MEMO

To: Kristopher Byrd, Well Construction and Compliance Section Manager
From: Joel Jeffery, Well Construction Program Coordinator
Subject: Review of Water Right Application G-18504
Date: July 12, 2018

Groundwater Application Review Summary Form

Application # G- 18504

Figure 2. Well Location Map

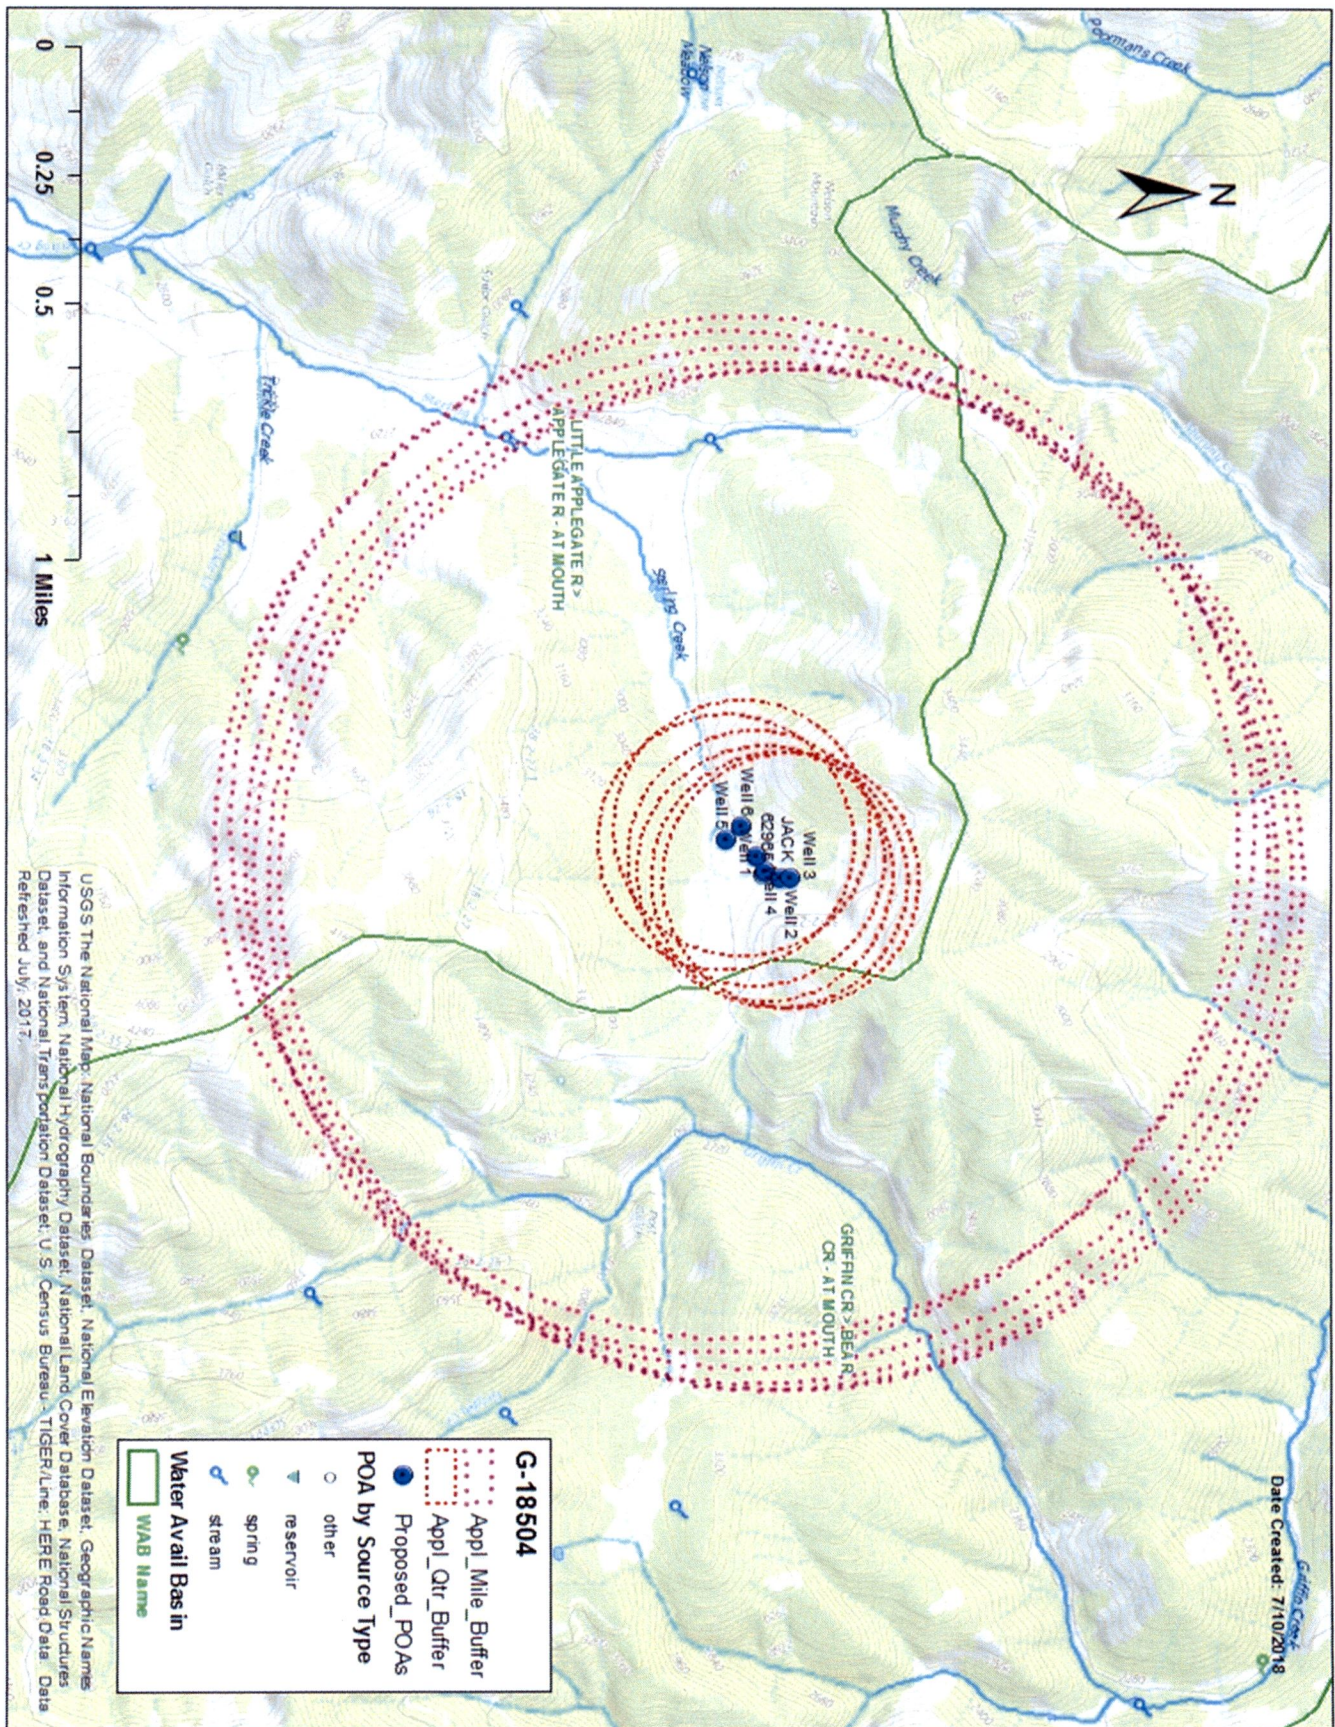
There are no groundwater POAs within 1 mile of the applicant’s POAs and relatively few domestic well logs for 38S/2W-27 so it is unlikely that the proposed use would injure adjacent senior water right holders. The reviewer notes that the proposed well field is very dense (6 wells within ~500 ft radius) and will likely result in well-to-well interference between the applicant’s POAs.

Basis for aquifer hydraulic connection evaluation: Groundwater elevations are higher than nearby surface water sources, indicating that water is flowing towards and discharging to surface water. The proposed POAs are within the Sterling Creek WAB but could affect flow paths that would otherwise contribute to Griffin Creek.
